Regarding: 04V-475

Technical BULLETIN

2005 XV250T ("Virago 250"), XT225T, and YW50T ("Zuma") FACTORY MODIFICATION CAMPAIGN – BRAKE REPLACEMENT

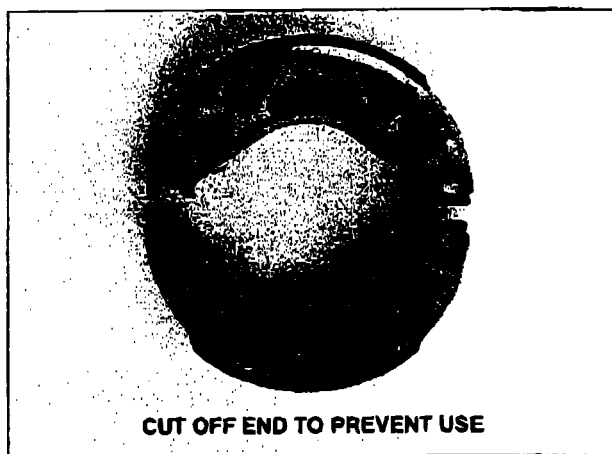
1. Replace the rear brake shoes with new ones.
2. Using a hacksaw, cut off a portion of the rounded end of each of the brake shoes that were removed to prevent their accidental reuse (see photo). Tag and hold the brake shoes for 90 days from the date you submit your Recall Request.

IDENTIFICATION PROCEDURE

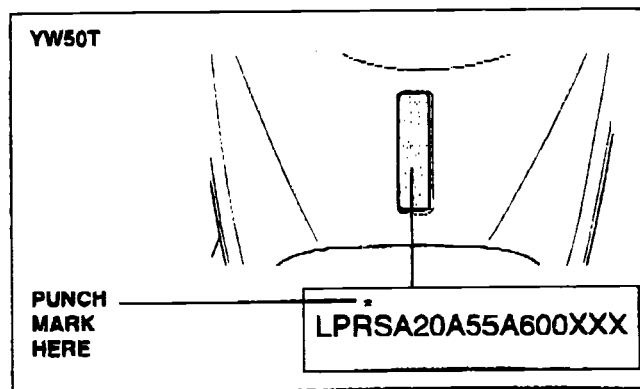
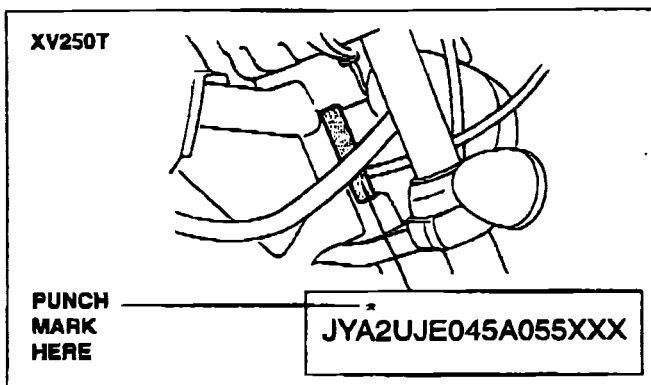
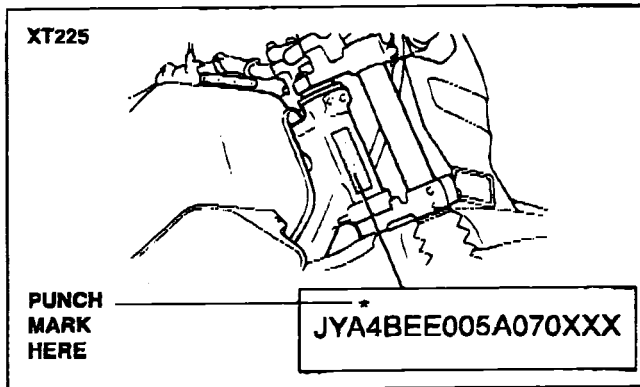
After modification, put a punch mark above the frame number (VIN) as shown.

Before modifying an unfamiliar unit, check for a punch mark next to the VIN on the frame to see if the modification has already been done.
